UNITED STATES PATENT AND TRADEMARK OFFICE

APPLICATION NO.	FILING DATE	FIRST NAMED INVENTOR	ATTORNEY DOCKET NO.	CONFIRMATION NO.
10/717,906	11/21/2003	Hye Yong Park	9988.082.00-US	7371

Office Action Summary

DETAILED ACTION

Marchand, Figure 3

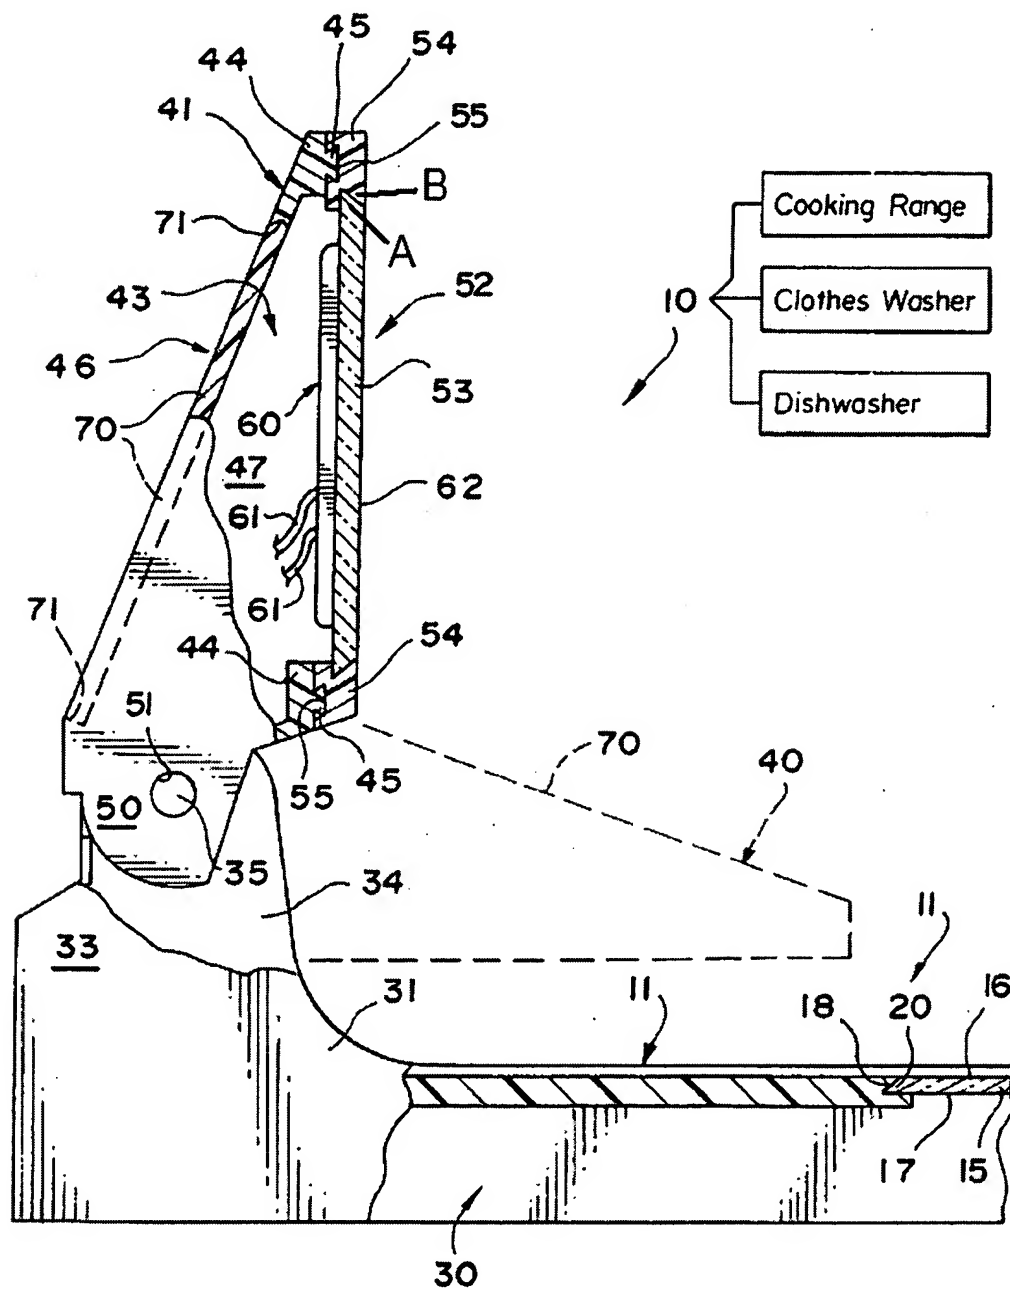
a. Regarding Claim 1, Marchand discloses a control panel assembly of a home appliance, the assembly comprising: a control panel (the rear assembly including 41, 54 and 60) having a contour according to a design of the home appliance (best seen in Marchand, Figure 1) and a display panel (53) attached to said control panel. Claim 1 is a product by process claim. The control panel assembly itself does not depend on the process of making it. The product-by-process limitation "wherein a planar contact between said display panel and said control panel is established through a thermal fusion technique" would not be expected to impart distinctive structural characteristics to the control panel assembly. The claimed control panel assembly appears to be the same or similar to that of Marchand.

b. Regarding Claim 2, Marchand further teaches that the display panel (53) is provided with a first interlocking means (A, best seen in Figure 3) along one edge and said control panel (the rear assembly including 41, 54 and 60) is provided with a second interlocking means (B, best seen in Figure 3) for receiving the first interlocking means.

c. Regarding Claim 3, Marchand further teaches that the first interlocking means (A) of said display panel (53) is a protrusion (best seen in Marchand,

Figure 3) and the second interlocking means (B) of said control panel (the rear assembly including 41, 54 and 60) is a recess (best seen in Marchand, Figure 3).
